**WILLIAM STATES LEE III
 NUCLEAR STATION UNITS 1 & 2**

Attachment 4

Revisions to FSAR Chapter 2, Subsection 2.5.5

WILLIAM STATES LEE III
 NUCLEAR STATION UNITS 1 & 2
 Best Estimate Layer Velocity
 Profile G, Generic Engineered
 Granular Fill Profile – GW
 FIGURE 2.5.4-251a

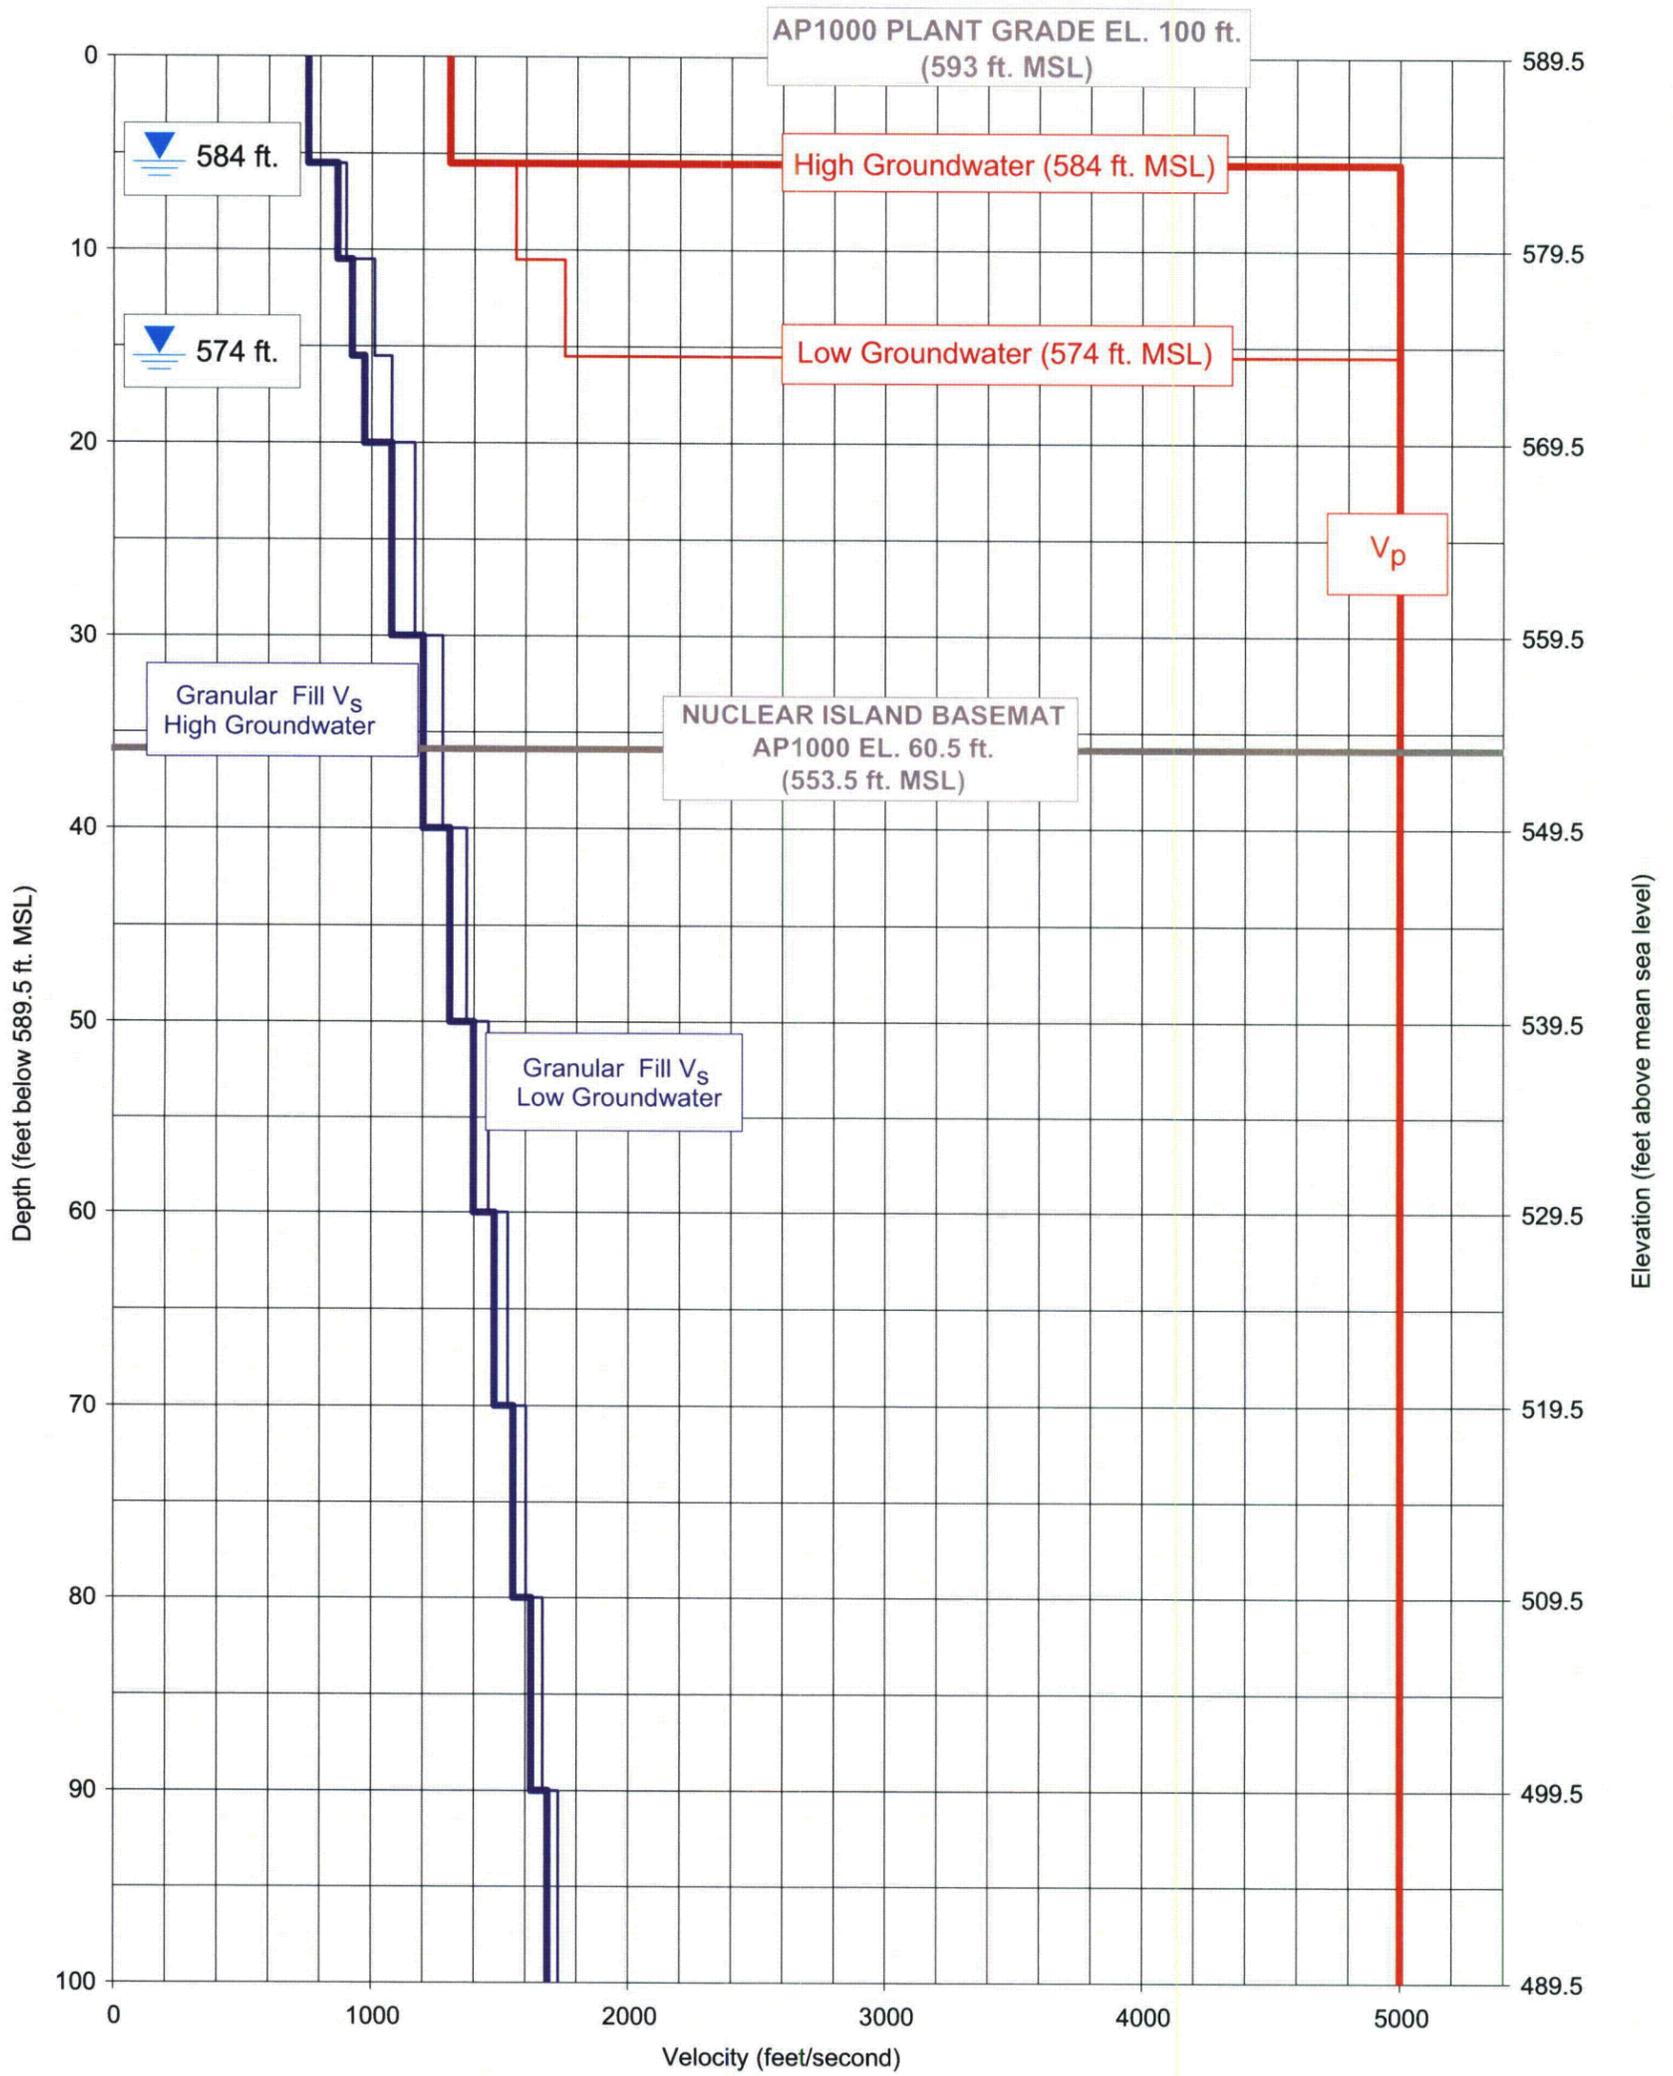
127. COLA Part 2, FSAR Chapter 2, Figure 2.5.4-251a is revised as follows:

WILLIAM STATES LEE III
 NUCLEAR STATION UNITS 1 & 2
 Best Estimate Layer Velocity
 Profile G, Generic Engineered
 Granular Fill Profile – GP
 FIGURE 2.5.4-251b

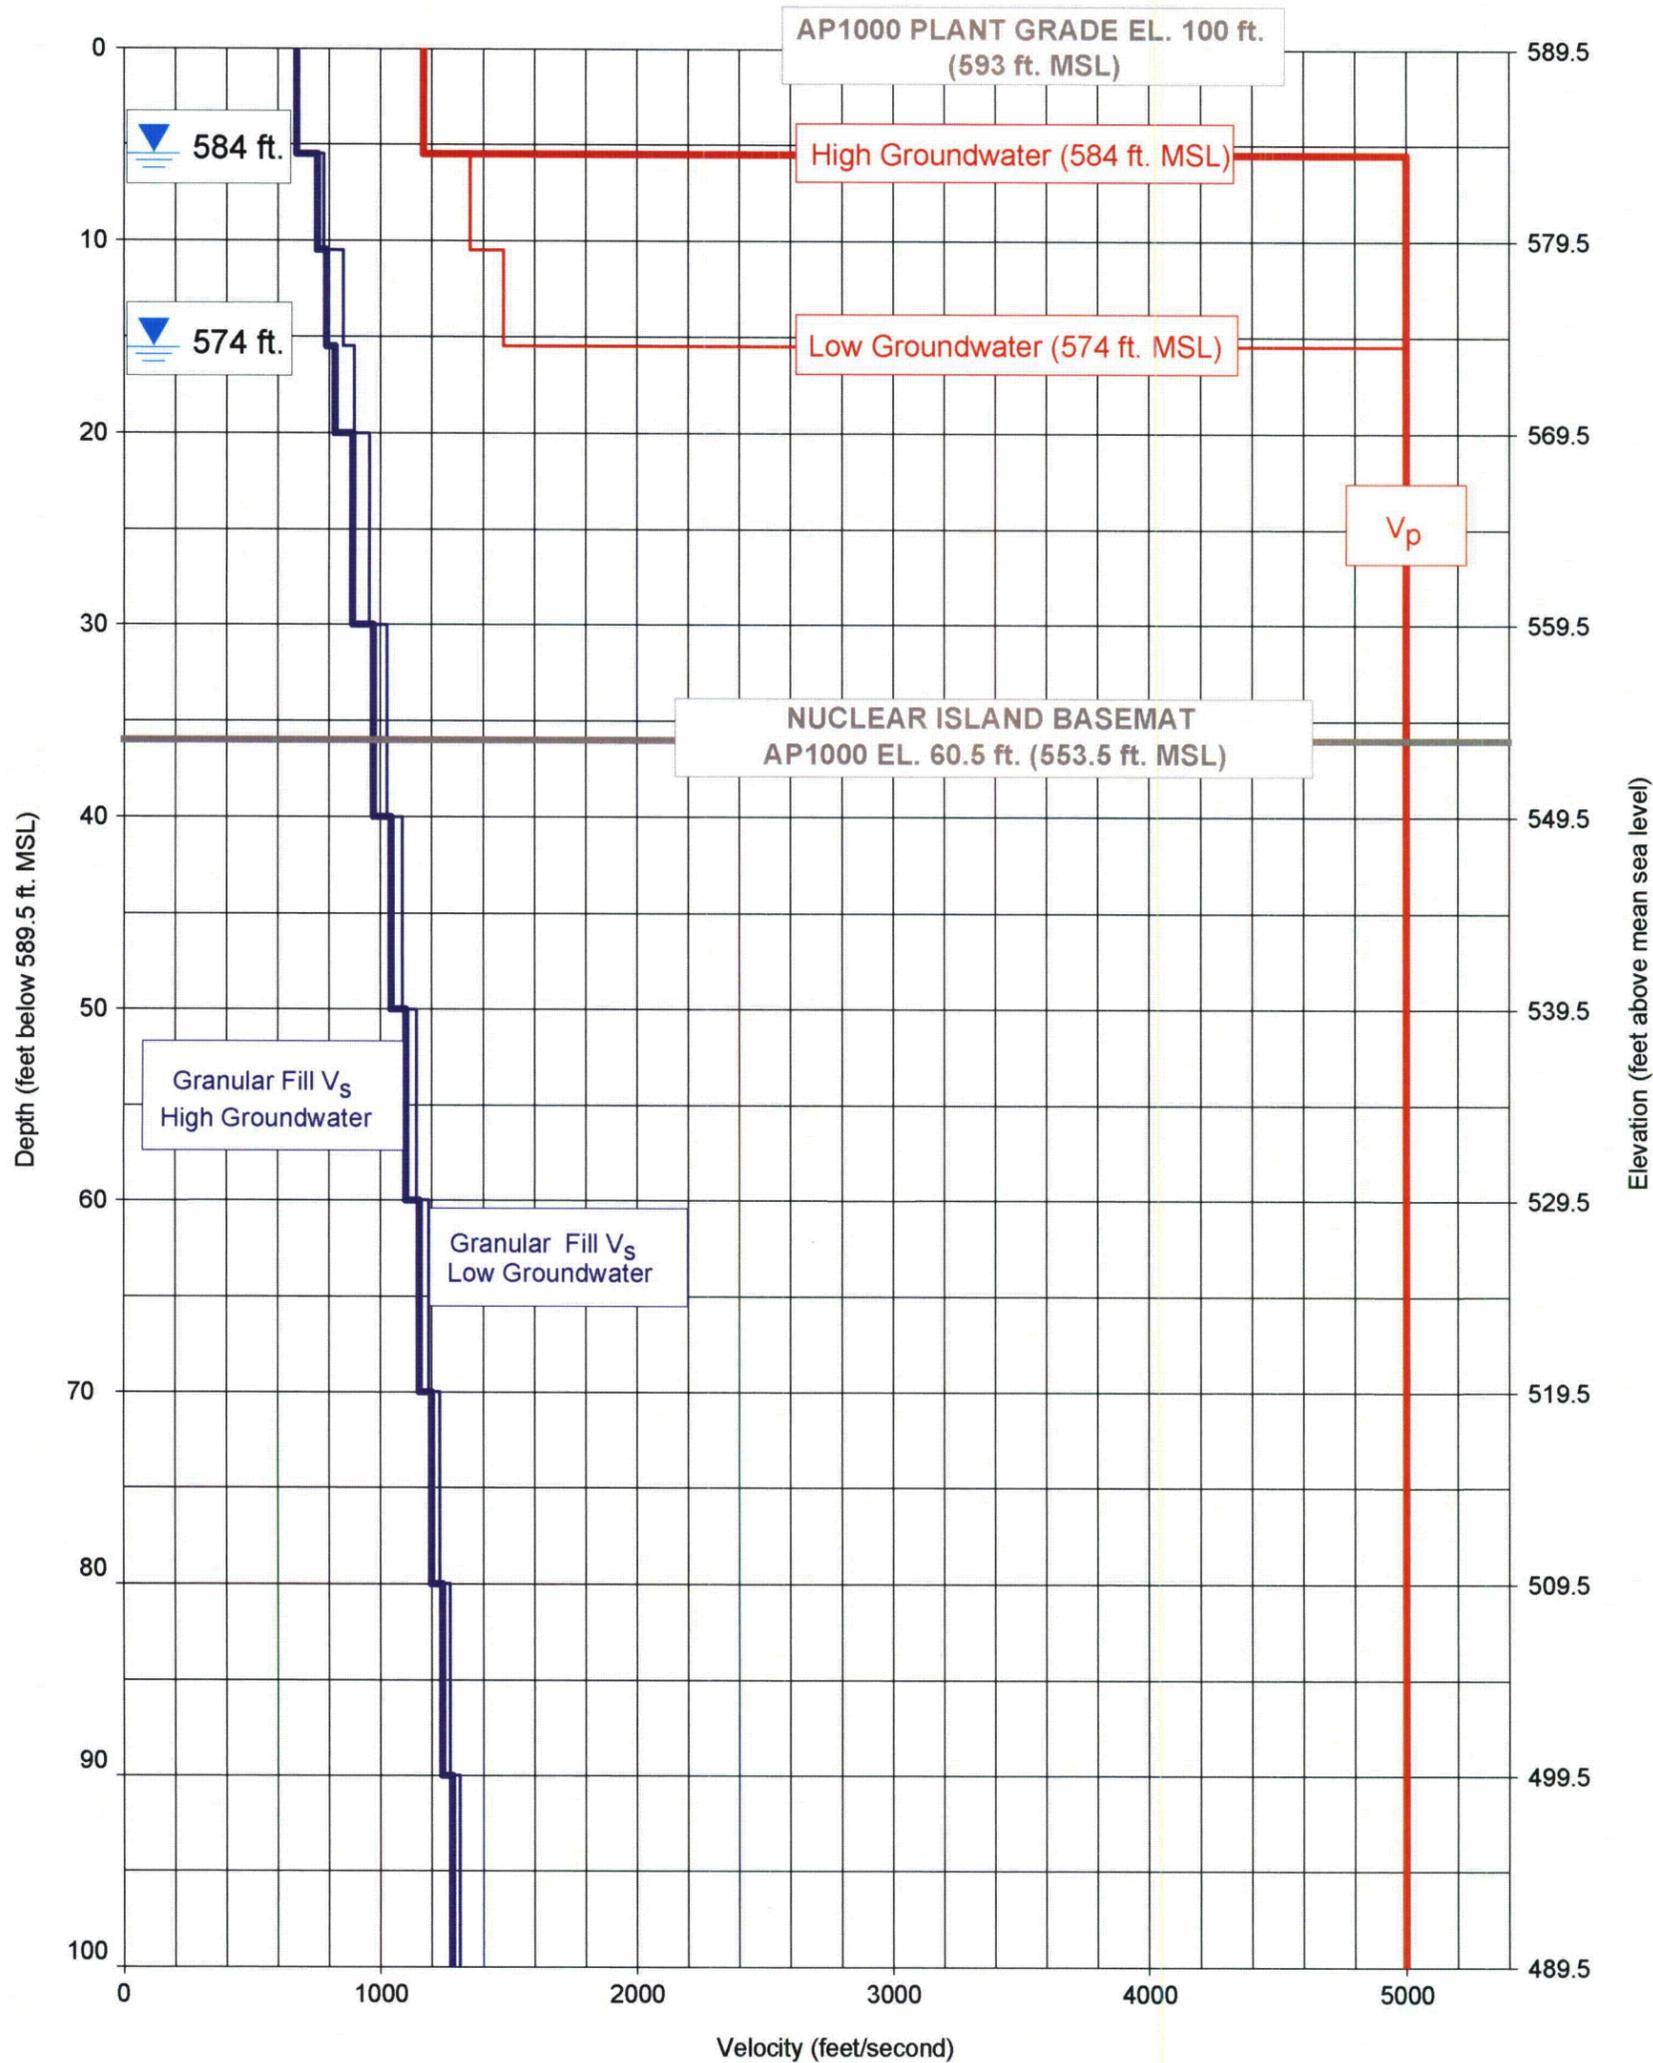
128. COLA Part 2, FSAR Chapter 2, Figure 2.5.4-251b is revised as follows:

WILLIAM STATES LEE III
 NUCLEAR STATION UNITS 1 & 2
 Best Estimate Layer Velocity
 Profile G, Generic Engineered
 Granular Fill Profile – SW
 FIGURE 2.5.4-251c

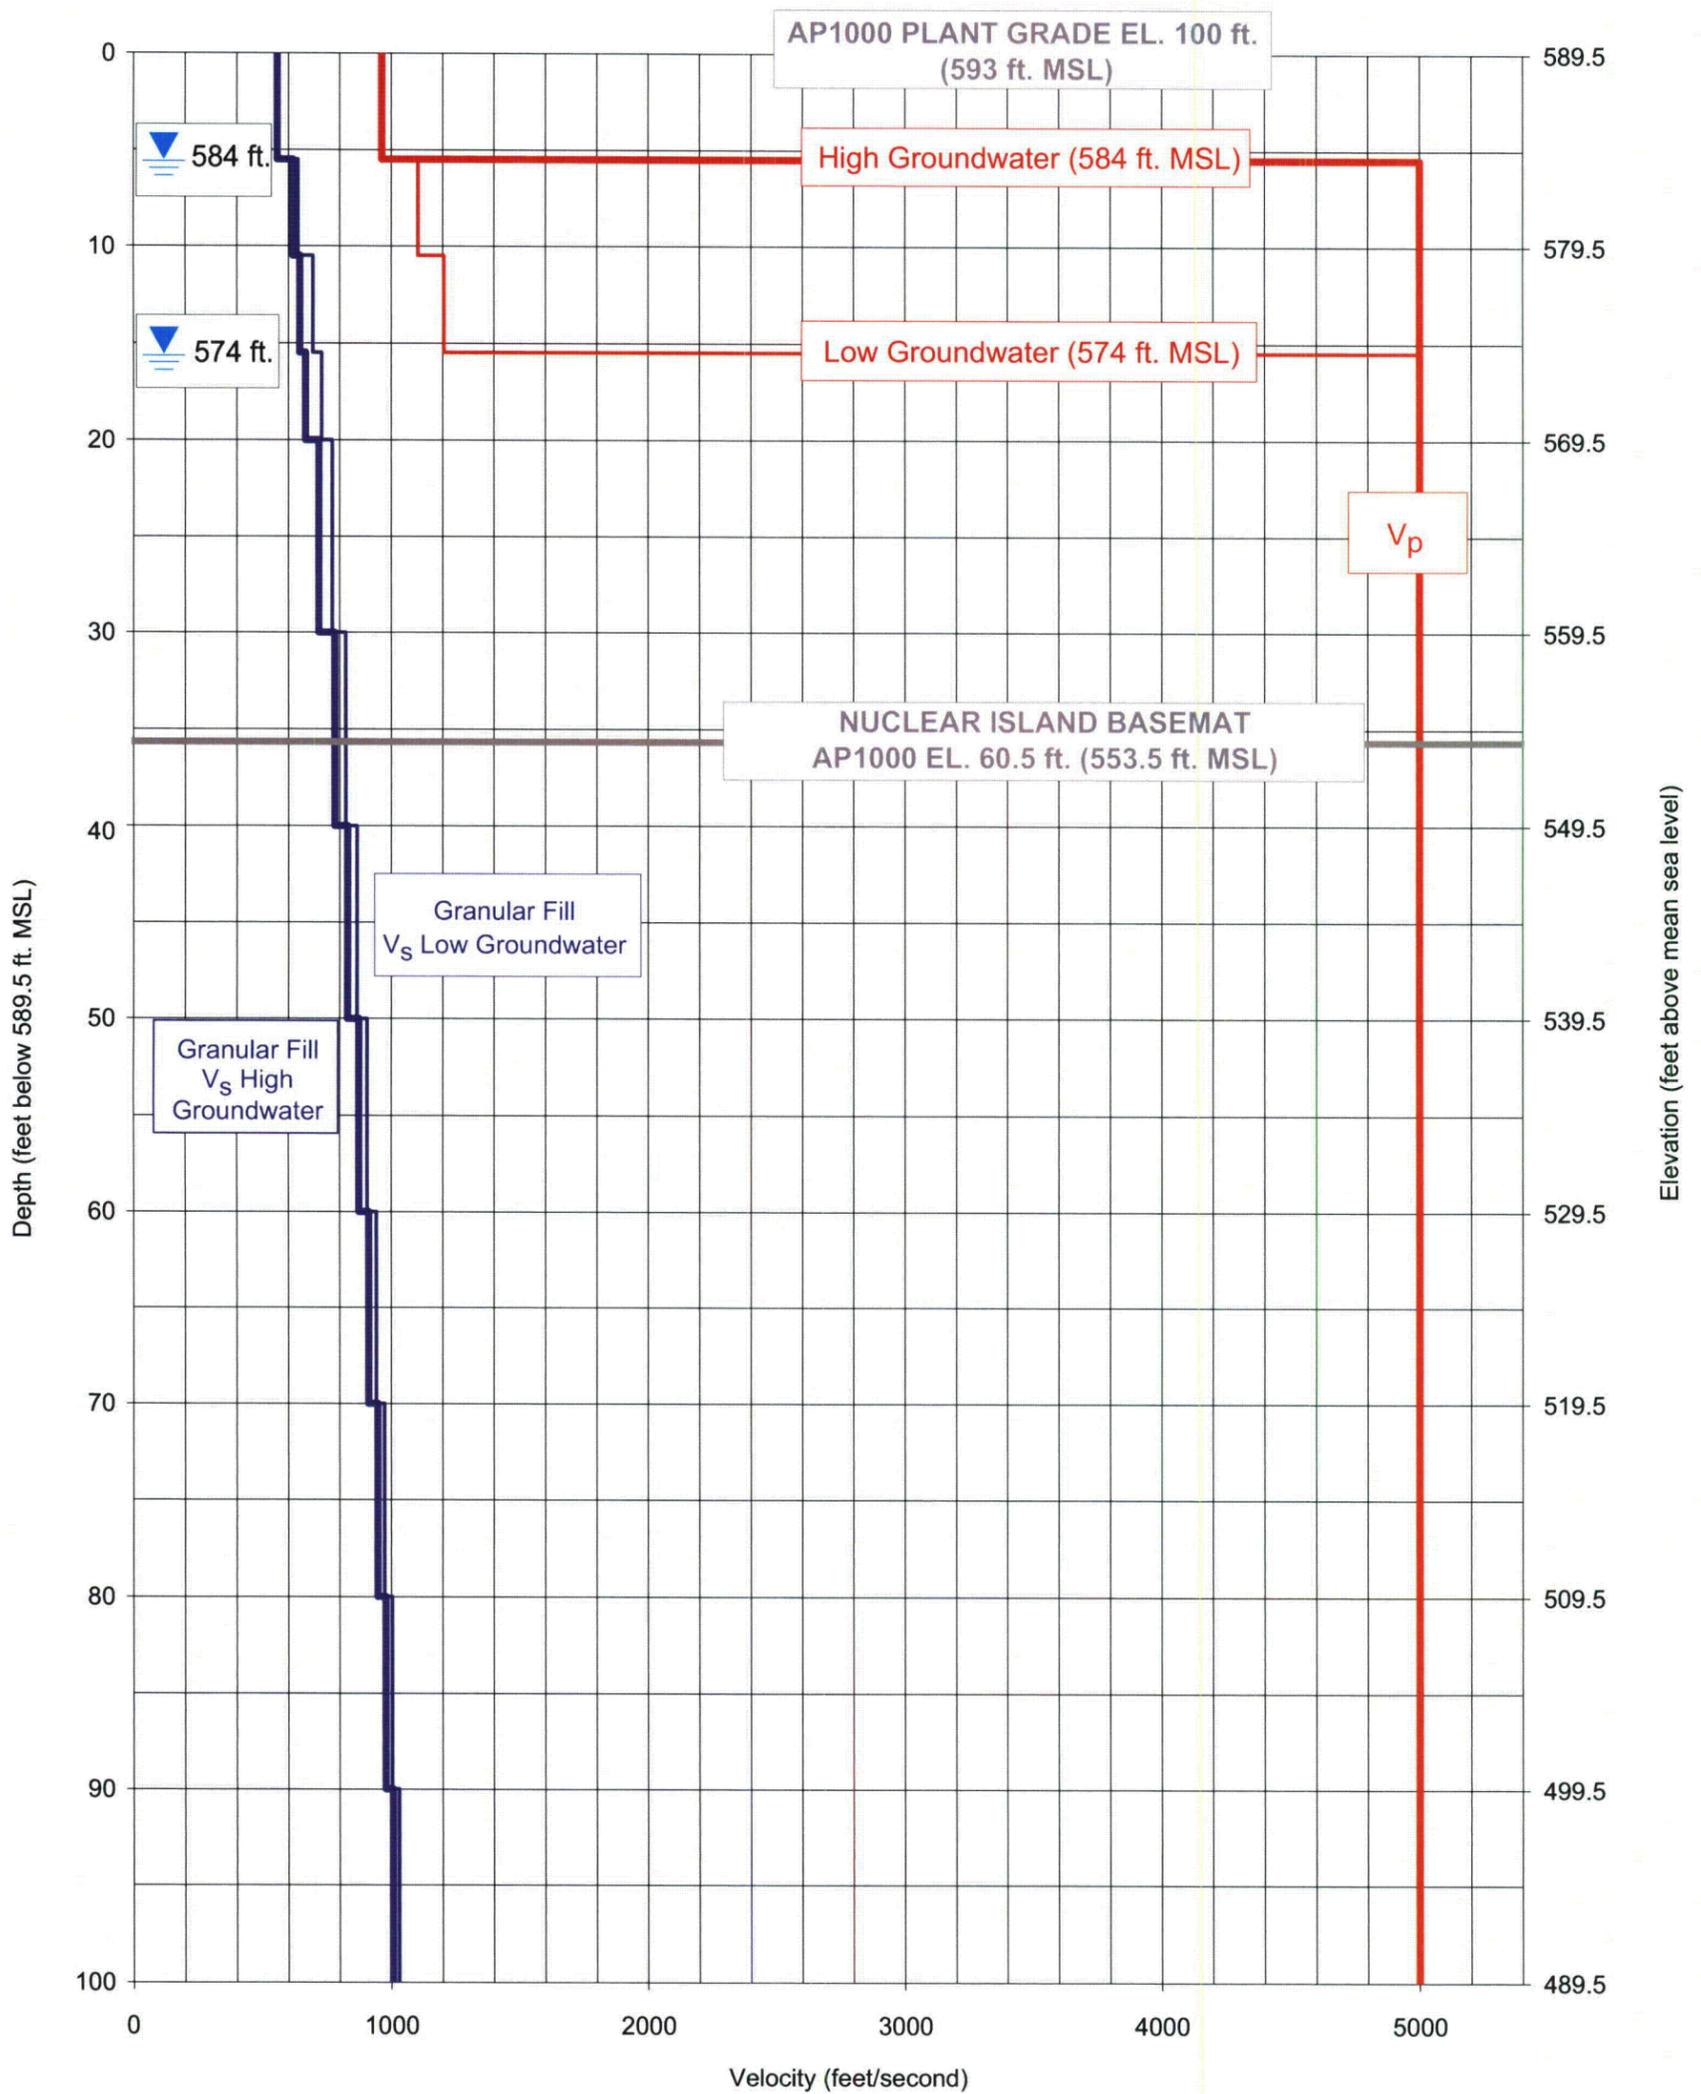
129. COLA Part 2, FSAR Chapter 2, Figure 2.5.4-251c is revised as follows:

FIGURE 2.5.4-255a

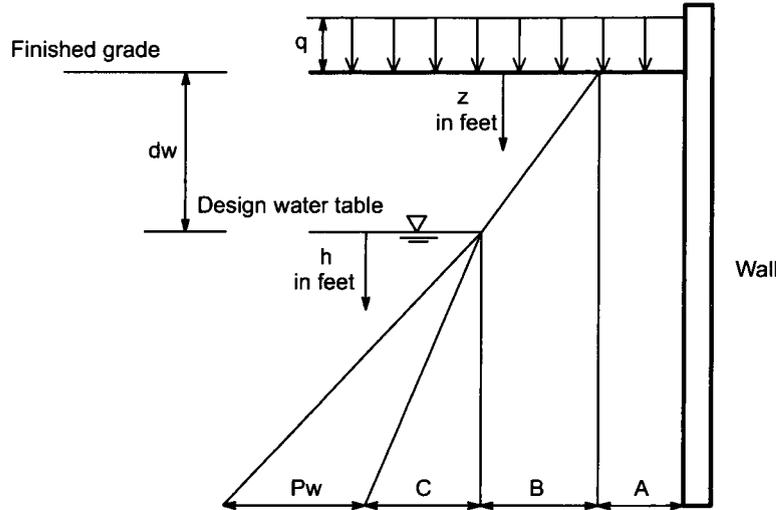
134. COLA Part 2, FSAR Chapter 2, Figure 2.5.4-255a is revised as follows:
